Ameren Transmission Company of Illinois's
Response to ICC Staff Data Requests
Docket No. 12-0598

Petition for a Certificate of Public Convenience and Necessity, pursuant to Section 8-406.1 of the Illinois Public Utilities Act, and an Order pursuant to Section 8-503 of the Public Utilities Act, to Construct, Operate and Maintain a New High Voltage Electric Service Line and Related Facilities in Various Counties in the State of Illinois.
Data Request Response Date: 12/27/2012

Page 7 of 19
ILL. C. C. DOCKET NO. 12-0598
Staff-ATXI Int. Exhibit No. 1
Witness _____
Date 5/17/13 By MA

765_Ameren_Area

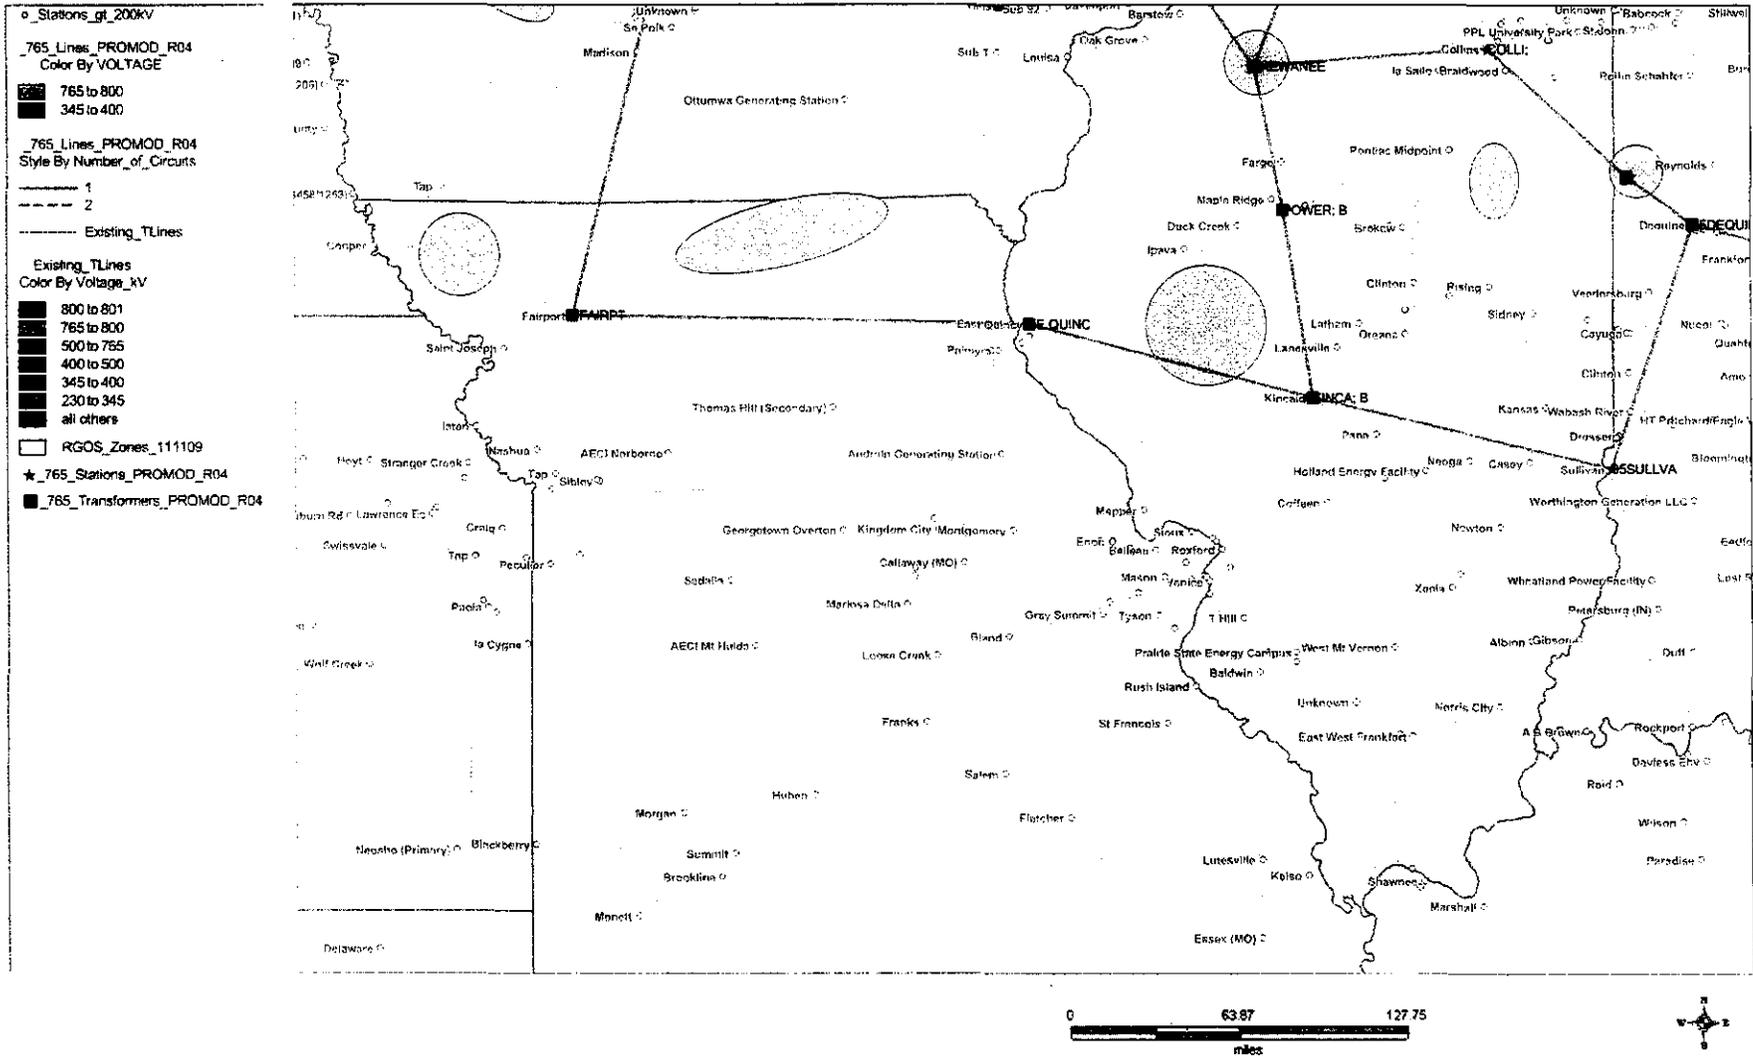
Please state whether ATXI considered utilizing the existing 345 kV transmission line between Pawnee and Kincaid by constructing a new 345 kV transmission line from Kincaid to Mt. Zion as an alternative to the Pawnee-Pana-Mt. Zion segments it proposes to construct with its petition in order to move electricity from west to east across Illinois. If ATXI did so, please provide the results of ATXI's and/or MISO's studies that caused ATXI to reject this alternative. If ATXI did not, why did ATXI not consider this alternative?

ATXI did not specifically consider a Kincaid - Mt. Zion 345 kV line as an alternative to the Pawnee-Pana-Mt Zion portion of the Illinois River Project. However the MISO multi-year RGOS and MVP portfolio development process examined numerous system configurations including the attached drawing which is one of several iterations considered (see ENG 6.01 Attach). Some additional configurations considered are described on page 35 of the MISO MVP Report and pages 62 and 63 of the MTEP11 Report. The RGOS and MVP development meetings were open to all stakeholders and ComEd transmission planners were participants with the opportunity to provide input during the evaluation of various potential system configurations (see Attachment A to Rebuttal Testimony of Jeff Webb, MISO).
